<b>SUNDRY NOTICES AND REPORTS ON WELLS</b> (DO NOT USE THIS FORM FOR PROPOSALS TO DRILL OR TO DEEPEN OR PLUG BACK TO A DIFFERENT RESERVOIR. USE "APPLICATION FOR PERMIT" (FORM C-101) FOR SUCH PROPOSALS.)		WELL API NO. <b>30-045-38314</b>

2. Name of Operator <b>SIMCOE LLC</b>		6. State Oil & Gas Lease No. <b>NMNM03358</b>
3. Address of Operator <b>1199 MAIN AVE., STE #101, DURANGO, CO 81301</b>		7. Lease Name or Unit Agreement Name <b>NORTHEAST BLANCO UNIT</b>

4. Well Location Unit Letter <b>D</b> : <b>735</b> feet from the <b>NORTH</b> line and <b>745</b> feet from the <b>WEST</b> line Section <b>12</b> Township <b>31N</b> Range <b>7W</b> NMPM County <b>SAN JUAN</b>		8. Well Number <b>004H</b>

Sundry ID: 2750468

## Wellbore Schematic

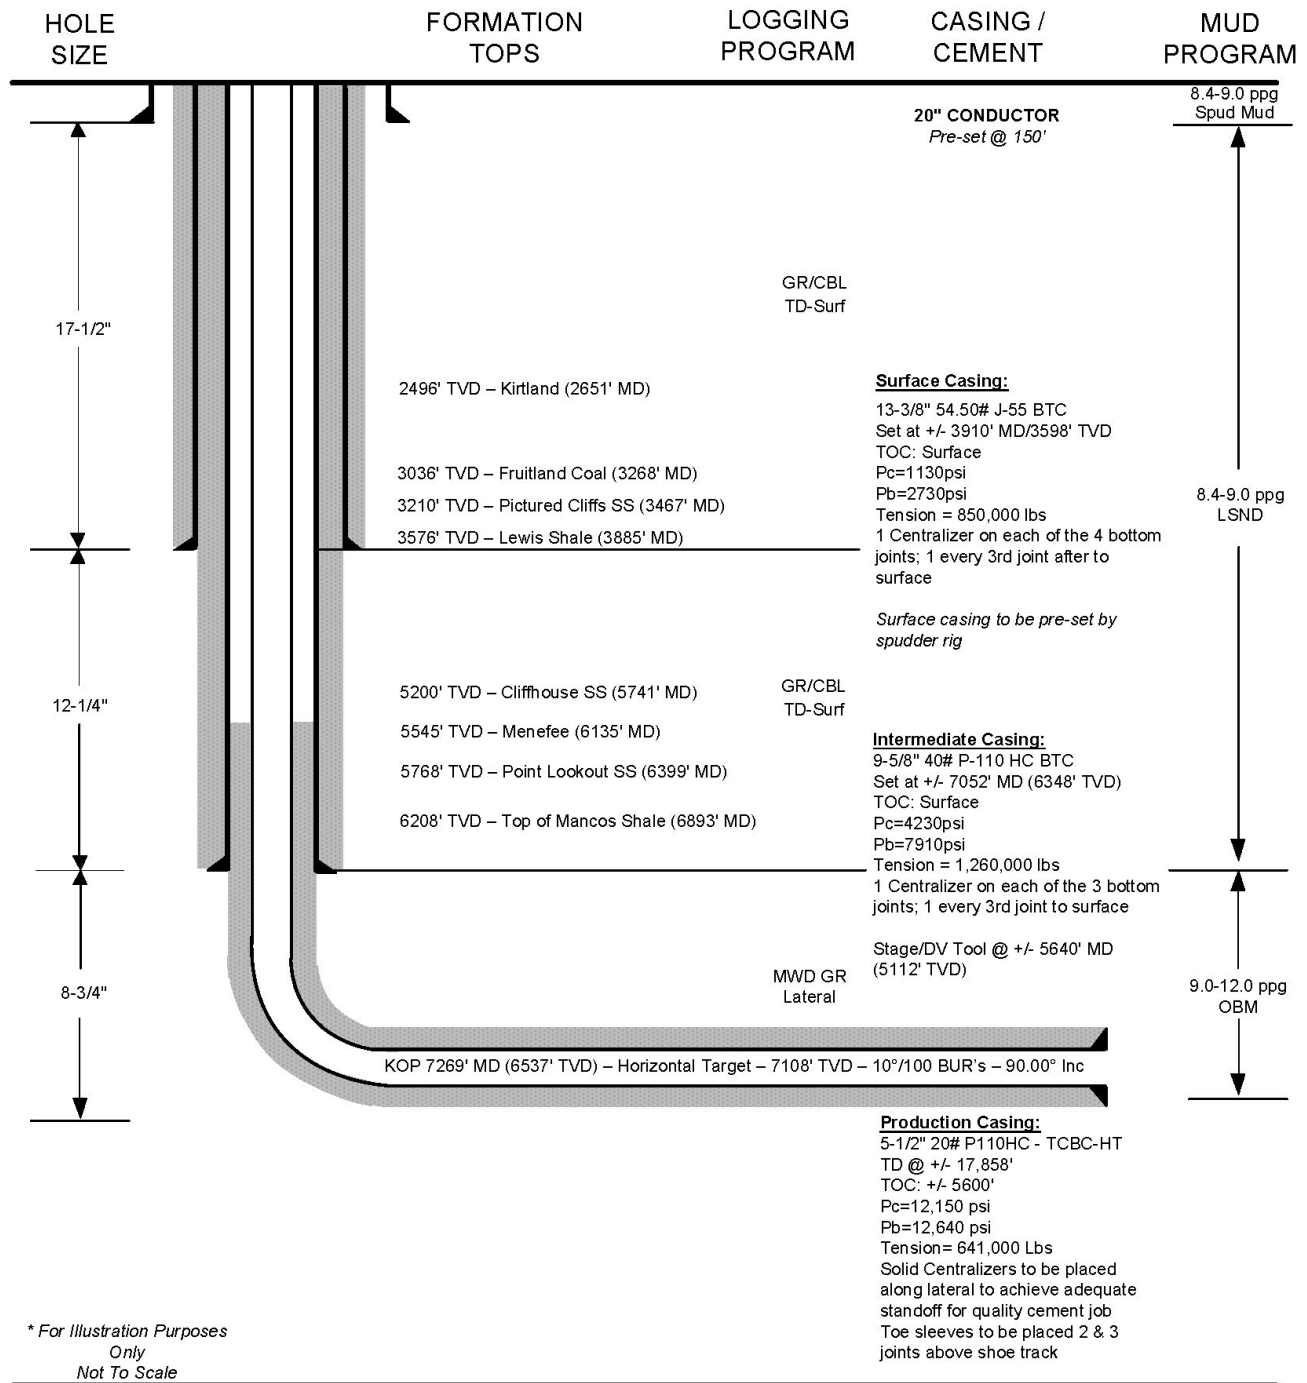
SIMCOE LLC is requesting to extend the Surface Casing to 3,598' TVD.

Current Surface Casing Program (as approved in the APD):

Casing size 13-3/8" set at ±1100' TVD; conventional cement job (1 stage), circulated to surface.

Revised Surface Casing Program:

Casing size 13-3/8" set at ±3598' TVD (roughly 25' into the Lewis Shale); conventional cement job (1 stage), circulated to surface.

To mitigate expected lost circulation problems in previously designed long (±5500' MD), deviated intermediate casing section; extreme lost circulation encountered both in offset operator's wells in addition to historic BP NEBU wells; will allow depleted intervals in Kirtland, Fruitland Coal, & Pictured Cliffs to be isolated behind pipe (surface casing) before drilling into the known depleted intervals in the Mesa Verde section; setting surface casing deeper (into the Lewis) allows for improved drilling efficiency & also increases the safety of drilling operations through these depleted sections.

## Wellbore Schematic

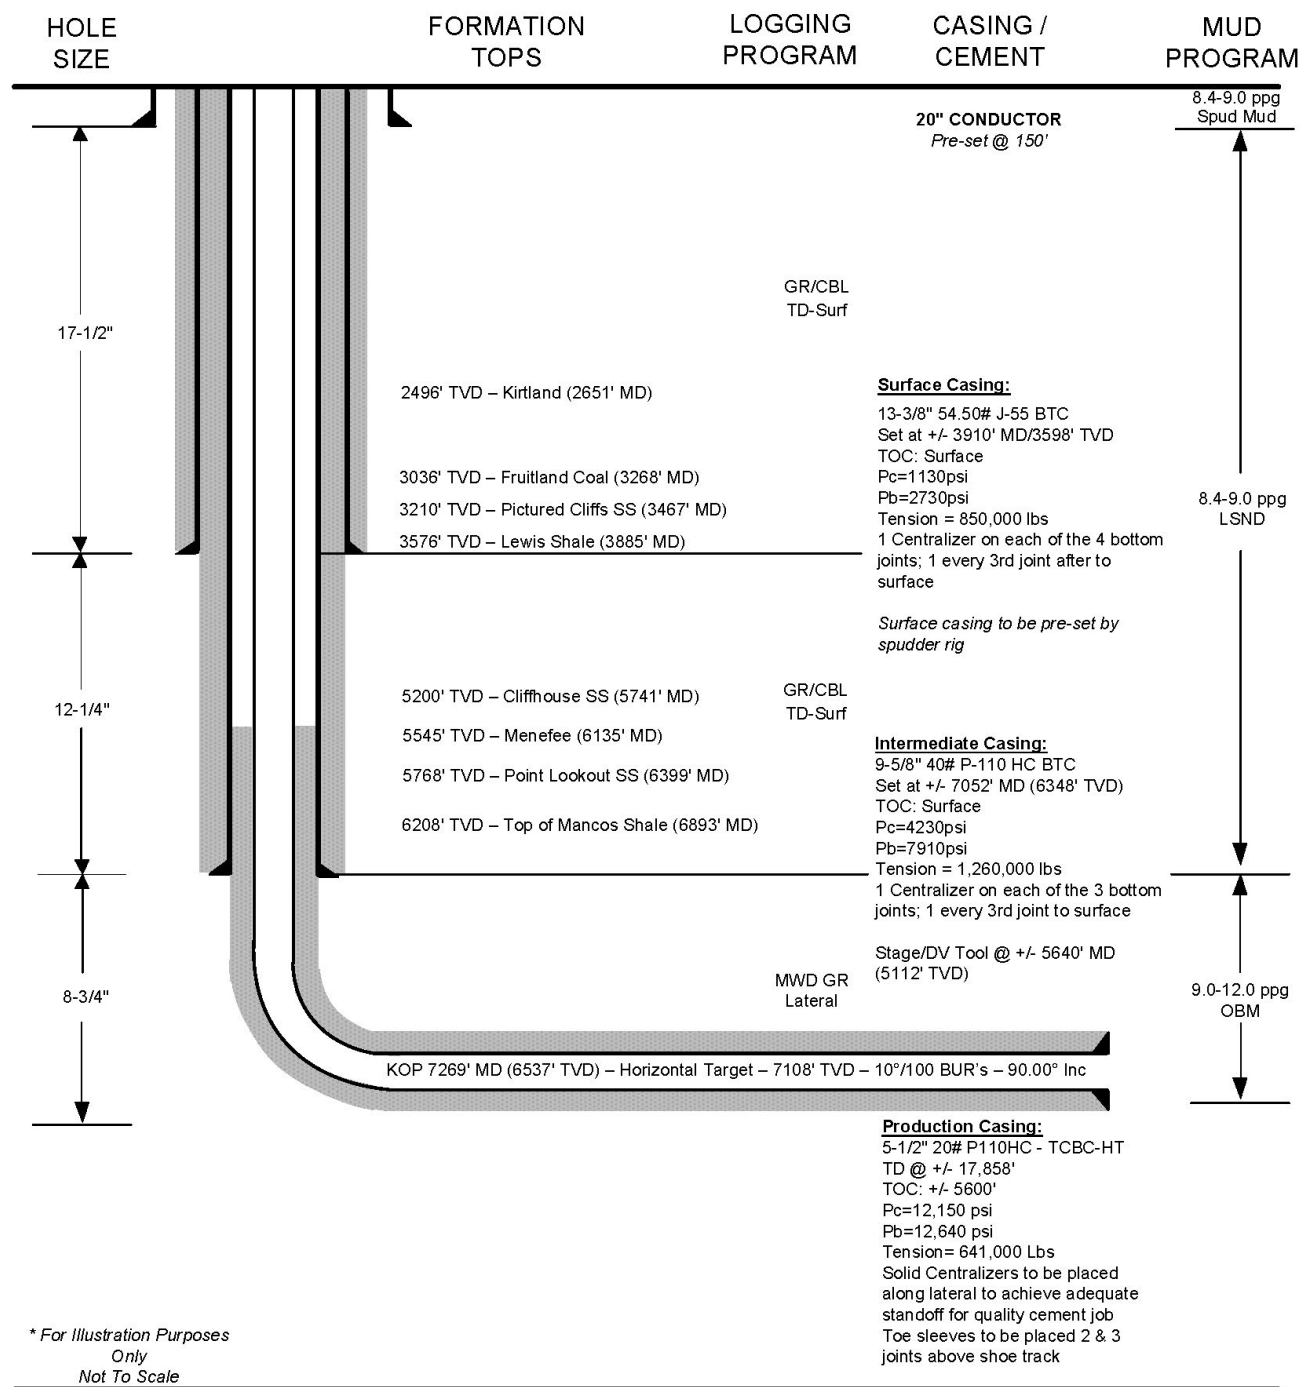
Reasons for setting deeper surface casing.

- to mitigate expected lost circulation problems in previously designed long (5500 MD), deviated intermediate casing section
- extreme lost circulation encountered both in offset operators wells in addition to historic BP NEBU wells
- will allow depleted intervals in Kirtland, Fruitland Coal, & Pictured Cliffs to be isolated behind pipe (surface casing) before drilling into the known depleted intervals in the Mesa Verde section
- setting surface casing deeper (into the Lewis) allows for improved drilling efficiency & also increases the safety of drilling operations through these depleted sections

Please see attached NEBU 602-4H Revised Casing and Cement Program for details.

Created By	Condition	Condition Date
dmcclure	Fresh water-based mud shall be used when drilling the hole for the surface casing.	10/11/2023
dmcclure	If cement does not circulate for the surface casing, Simcoe shall do the following; (a) contact the Division's Northern Compliance Officer Supervisor and coordinate the remediation of the cement; (b) provide the Division a CBL demonstrating competent cement after the remediation of the cement; and (c) not proceed with drilling the well until approved to do so by the Division.	10/11/2023
